SUBJECT: Responds to 980123 RAI re NRC GL 87-02, "Verification of Seismic Adequacy of Mechanical & Electrical Equipment in Operating Reactors, Unresolved Safety Issue (USI) A-46."

AEP:NRC:1040G

Donald C. Cook Nuclear Plant Units 1 and 2
RESPONSE TO REQUEST FOR ADDITIONAL INFORMATION (RAI)-NRC GENERIC
LETTER 87-02, "VERIFICATION OF SEISMIC ADEQUACY OF MECHANICAL AND
ELECTRICAL EQUIPMENT IN OPERATING REACTORS, UNRESOLVED SAFETY
ISSUE (USI) A-46." (TAC NOS. M69437 AND M69438)

RESPONSE TO REQUEST FOR ADDITIONAL INFORMATION

Figure 2a 2-BC-B-PNL outline drawing.

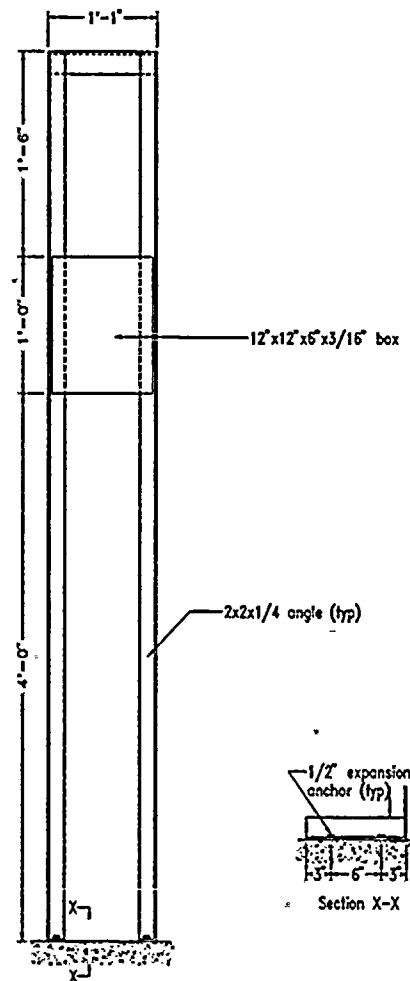
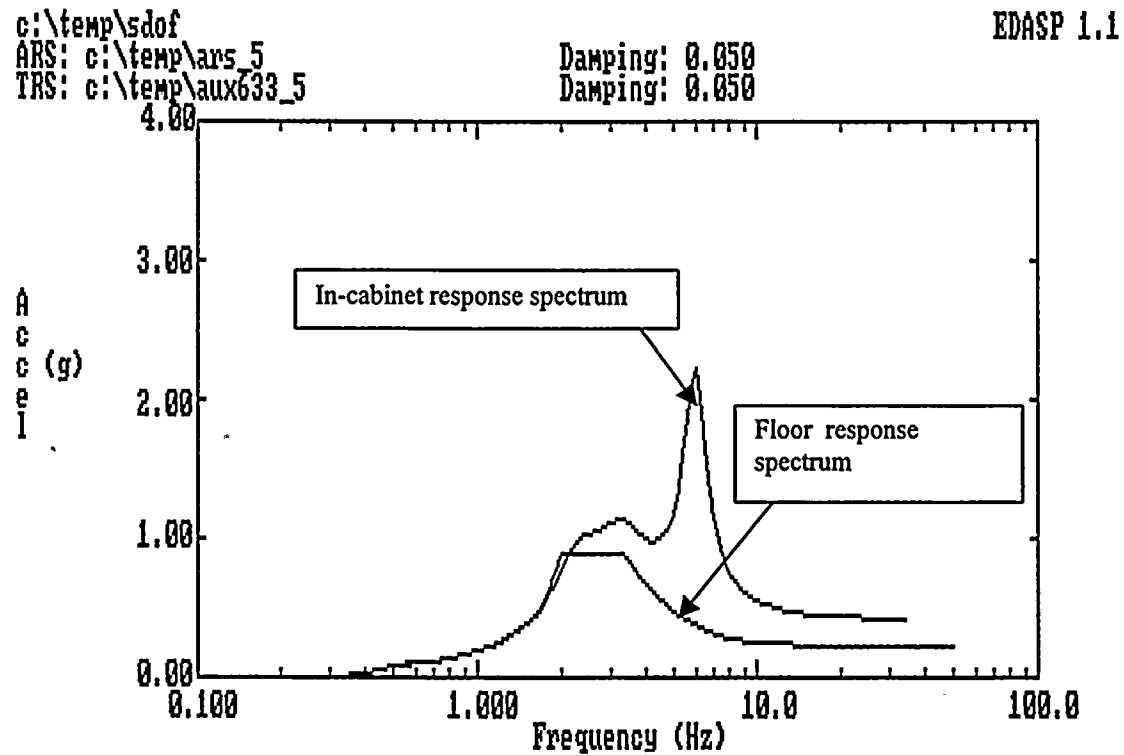
10. *In Appendix E of Attachment 3 (Reference 1), Footnote (9) of the Unit 1 essential relays' capability vs. demand summary table indicates that the amplification of certain relay panel was calculated using case specific analysis. Considering relay panel under Tag Number 2-88X1-BCB as an example, provide an illustration how the case specific analysis was performed.*

Response to Question 10:

The subject relay is housed in cabinet 2-BC-B-PNL. An outline drawing of the cabinet and the calculated in-cabinet response spectrum was provided in Appendix D of Attachment 3 to AEP:NRC:1040C and is also provided here.

The cabinet consists of a small junction box (12"x12"x 6") containing two relays. The box is mounted on a flexible stand constructed of 2"x2"x1/4" steel angles (see Figure 2a on page 11). The cabinet is modeled as a single-degree-of-freedom (SDOF) system with a stiffness of 384 lb/in (two 4.5' long 2x2x1/4 cantilevers), a weight of 64 lbs (31 lbs for the box, 10 lbs for the contents, and 23 lbs for half the weight of the steel). This yields a frequency of 7.7 Hz, which is reduced by 20% to 6 Hz to account for any uncertainties in the calculation (the reduction is conservative because the floor response spectrum increases with decreasing frequency). The in-cabinet response spectrum (ICRS) is calculated using 3% cabinet damping and using the same direct generation calculation embodied in GENRS (which was accepted by the NRC on page 26 of GIP SSER No. 2). The 5% damped ICRS and FRS (floor response spectrum) are shown in Figure 2b. The ICRS has a peak value between 4

Hz and 16 Hz of 2.2g and a ZPA of 0.42g. These values are multiplied by 1.5 and the resulting values of 3.3g peak / 0.63g ZPA are used as the relay demand.

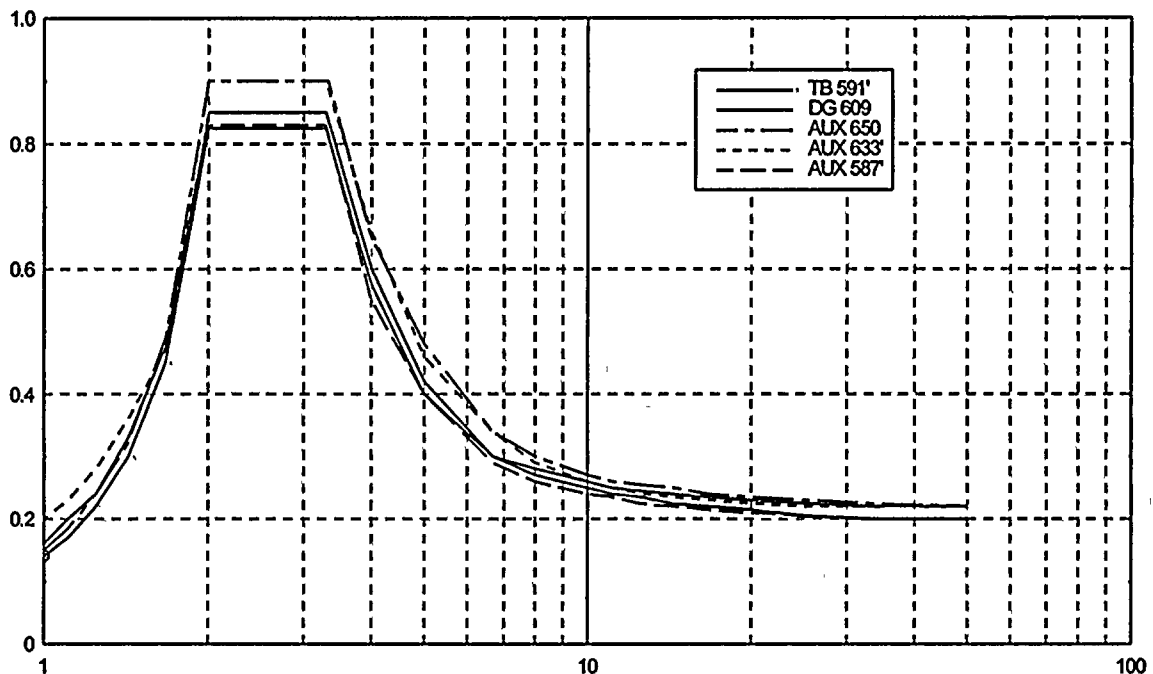
11. In Appendix E of Attachment 3 (Reference 1), Footnote (20) of the Unit 1 essential relays' capability vs. demand summary table indicates that for relays located between elevations for which floor response spectra were developed, the next highest elevation was used. As indicated in many cases, the developed response spectra may not pertain to the same building in which the relays to be seismically verified are located. Explain how the pertinent response spectra were selected for this population of relays.

Response to Question 11:

The A-46 floor response spectra for structures other than the Containments are shown in the following figure.

The Auxiliary and Diesel Generator Buildings are independent reinforced concrete structures founded on a common mat. The top of the mat is at elevation 587' except for a portion of the Auxiliary Building where it drops down to elevation 562'. As can be seen from the floor response spectra, the seismic response of these structures is typical of deep soil sites: the entire foundation mat translates uniformly at a low frequency, with little inter-story building deformation - note that there is little difference in the response spectra for different elevations.

The majority of cabinets are floor mounted - the corresponding floor response spectrum was used to calculate the seismic demand on the relay.

Some of the cabinets are wall mounted or floor mounted in an area not at one of the standard elevations; in these cases, the floor response spectrum for the next higher elevation was used. As noted in the above figure, the floor response spectra for the different elevations are only slightly different and do not have a very significant impact on the relays' seismic demand.

Unit 1 - Aux Building - Area around Containment from Az 90° to Az 360° (RACE103)

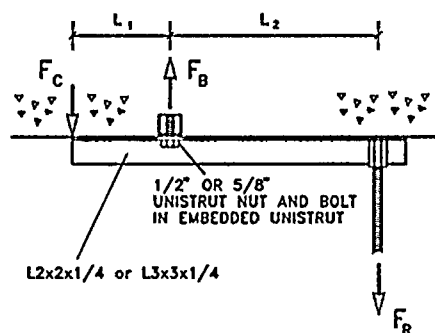
A common (but not prevalent) rod hanger anchorage detail used at Cook is shown below. In most cases it has an acceptable configuration: $L_2 \leq L_1$ and $L_2 + L_1 \leq 12"$. The worst-case configuration consisted of a heavily loaded hanger (1200 lb dead weight) with $L_2 = 10"$ and $L_1 = 2"$. This configuration does not meet the LAR requirements.

The recommended resolution to this outlier was to walk down the plant and document all occurrences of this detail, screen the specific configuration of each detail using acceptance criteria based on the LAR requirements. Fifty occurrences were found and documented, 12 did not meet the screening criteria. All supports not meeting the screening criteria will be modified to satisfy the GLP-2 requirements. This work is being carried out under Design Change No. 208 and it is presently scheduled to be completed during the current plant outage.
